**2.0 Telematics Control Unit (TCU)
Upgrade - T17 to T27**

Date: May 1, 2025
Bulletin Name: FDM-SVC-041
Model: Oshkosh S-Series
Units Affected: 2.0 Front Discharge Mixers
VIN 821990 - 827769

This bulletin provides instruction for installing a T27 TCU module in place of a T17 TCU module.

Figure 2

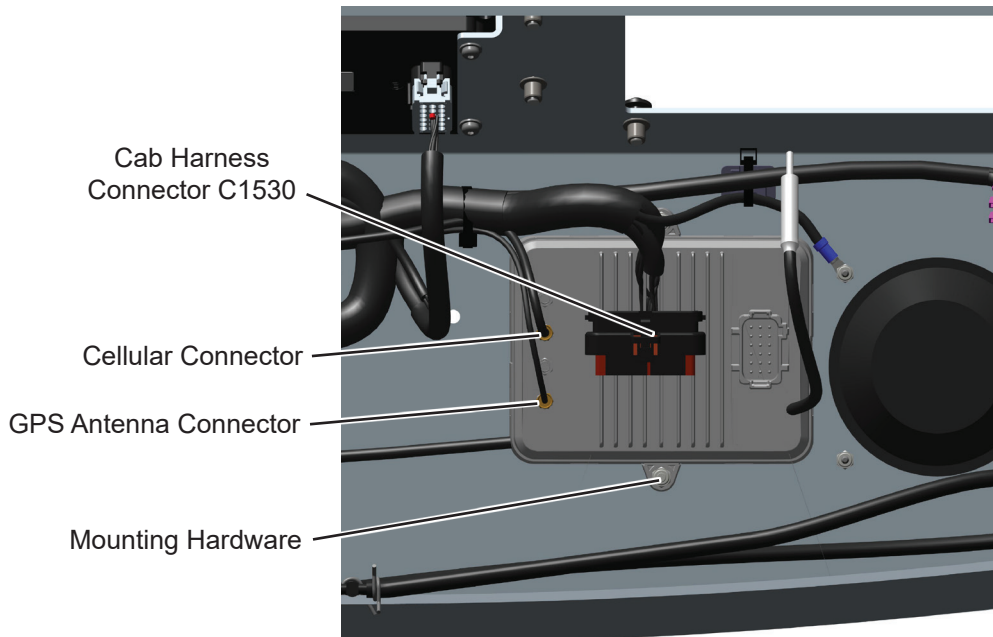
5. Disconnect cab harness connector C1530, GPS antenna connector, and cellular connector from T17 module. See Figure 2.
6. Remove screws and lock nuts securing T17 module to bottom of overhead console. See Figure 2. Screws and lock nuts will not be reused.
7. Remove T17 module from overhead console. See Figure 2. T17 module will not be reused.

Figure 3

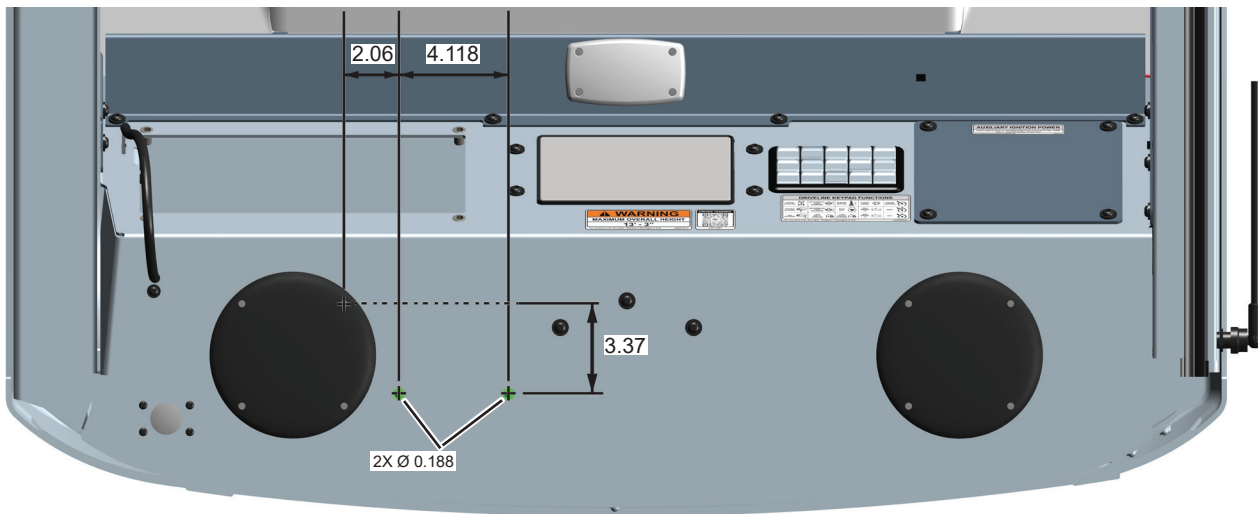
8. Mark and drill two 3/16 inch holes in bottom of overhead console per dimensions in Figure 3.

Figure 4

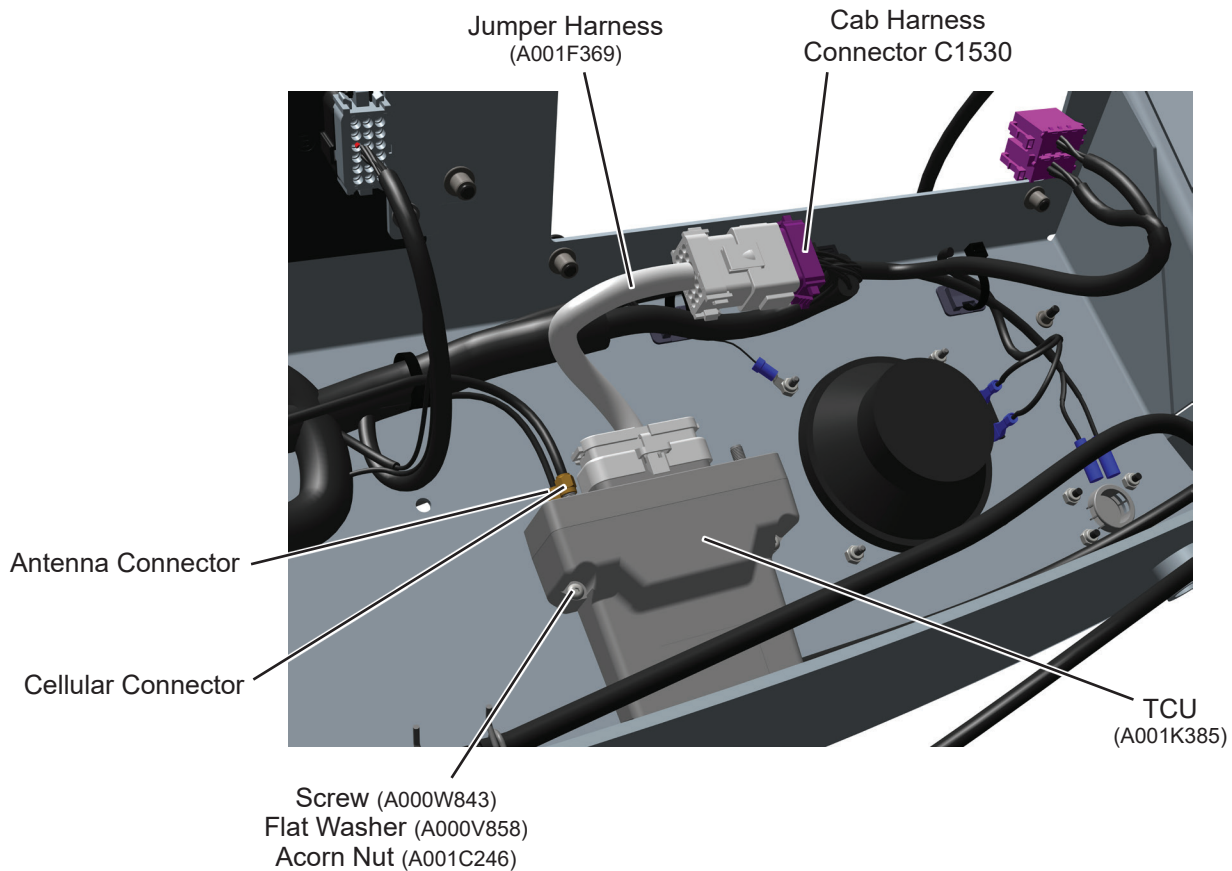
9. Place T27 TCU module (A001K385) in overhead console through radio panel opening. See Figure 4.
10. Apply Loctite® #242 (A000E542) to threads of mounting screws (A000W843).
11. Secure TCU module to overhead console through holes drilled in Step 8 with screws (A000W843), washers (A000V858), and acorn nuts (A001C246). See Figure 4. Install screws from top and washers and acorn nuts from the bottom, acorn nuts to be visible from driver's seat. Final tighten hardware to 17 in lbs.
12. Connect GPS antenna and cellular connectors disconnected in Step 5 to TCU module. See Figure 4.
13. Connect jumper harness (A001F369) to TCU module. See Figure 4.
14. Connect cab harness connector C1530 disconnected in Step 5 to jumper harness. See Figure 4.
